RiverOak Strategic Partners

Applicant's Answers to Fifth Written Questions

TR020002/11/FWQ
Examination Document

Project Name:	Manston Airport Development Consent Order
Application Ref:	TR020002
Submission Deadline:	11
Date:	5 July 2019

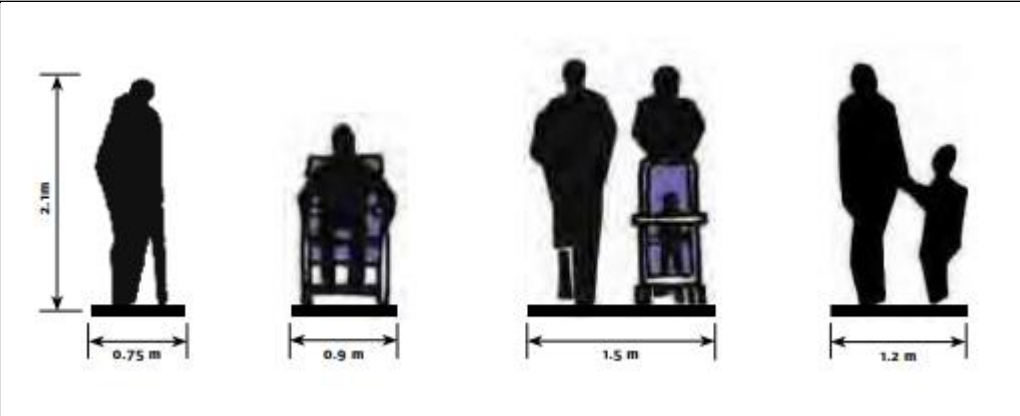
Ref No.	Respondent	Question
		<p><i>and the junction intervisibility requirements thereafter, and makes reference to compromised visibility and mitigation measures that can occur. The junction design and operation including stage extensions and inter-green times etc. will be developed during detailed design".</i></p> <p>iii. Is this acceptable to KCC?</p> <p>The Applicant states that this area of land is grass verge. However, aerial maps (google) show this containing numerous trees. Further, the Applicant's response to Fourth Written Question TR.4.29 (vii) states:</p> <p><i>"A very small area immediately adjacent to the highway, that is currently grass verge, will have to be maintained in its current condition so as not to create an obstruction to visibility. It is extremely unlikely that any infrastructure will be introduced onto this plot of land so as to impede visibility. The ExA can be satisfied that inter-visibility will be maintained".</i></p> <p>iv. Given that this area of land includes trees, justify this response and how this will be achieved.</p> <p>v. Why was this small plot of land not included within the DCO boundary?</p> <p>KCC's response to Fourth Written Question TR.4.29 (xii) [REP9—index number to be allocated] states:</p> <p><i>"The proposed narrowing of the footway on the Manston Road (north) arm to 1.26m is not considered acceptable in the vicinity of this busy junction".</i></p> <p>vi. What is the Applicant's response?</p> <p>vii. Why does KCC consider that this would impact on highway and pedestrian safety?</p>

Ref No.	Respondent	Question
		<p>iii) n/a</p> <p>iv) The small area of land outside of the highway boundary that is required for maintaining visibility as shown in Appendix TR.4.29 is a flat grassy verge in front of the MoD building and does not include trees. The trees near to this location merely overhang the land. As referred to in the Applicant's response to TR.4.29, junction intervisibility in accordance with Design Manual for Roads and Bridges (DMRB) standards (which relate to motorway and trunk roads) is regularly difficult to achieve in urban environments. Paragraph 2.18 of TD50/04 identifies that minor obstructions to visibility caused by slim obstructions within the junction intervisibility zone may be unavoidable. The Applicant acknowledges that the trees will require maintenance as part of regular upkeep by Kent County Council under their duty as the Highway Authority. This is in common with numerous hedgerows, verges and other roadsides around the country which are maintained by the respective Highways Authority.</p> <p>v) The DCO contains land required for capacity improvements, not for safety improvements.</p> <p>vi) The footway is less than 1.3m for only a very short distance of 0.73m and as such is a very minor pinch point. Either side of this pinch point, the footway width exceeds 1.3m. The path is never reduced in width of less than 1.25m. It is noted that the width of 1.26m is sufficient to accommodate a wheelchair (0.9m) and two people (1.2m), as illustrated in Figure 6.8 of the Design Manual for Streets, published by the Department for Transport, as reproduced below.</p> <p>Although the Design Manual for Roads and Bridges (DMRB) Volume 6, Section 3, Part 5 'The Geometric Design of Pedestrian, Cycle and Equestrian Routes' sets out that widths of 1.3m may be provided over short distances (paragraph 7.4), it should be noted that the minimum width for any footway is 1.0m (Department of Transport LTN2/04). The design of the footway at Manston Road and Spitfire Way is in excess of this.</p>

Ref No.	Respondent	Question
		<div data-bbox="745 320 1762 737">  </div> <p data-bbox="745 746 1442 775">Source: <i>Manual for Streets</i>, 2007, Department for Transport</p> <p data-bbox="745 823 2033 962">The proposed design will increase the safety of pedestrians at the junction. There is no provision in the current arrangement for controlled pedestrian crossings, while the proposed design provides safe controlled crossing points. It is considered that the scheme as a whole is a betterment to the pedestrian infrastructure in the location.</p> <p data-bbox="745 1010 2033 1115">In these circumstances, where there is an overall improvement in pedestrian and cycle facilities as a result of the Proposed Development, it would be expected that such a minor departure from standards would be acceptable.</p> <p data-bbox="647 1163 781 1192">vii) n/a</p>
TR.5.4	KCC	Junction 15
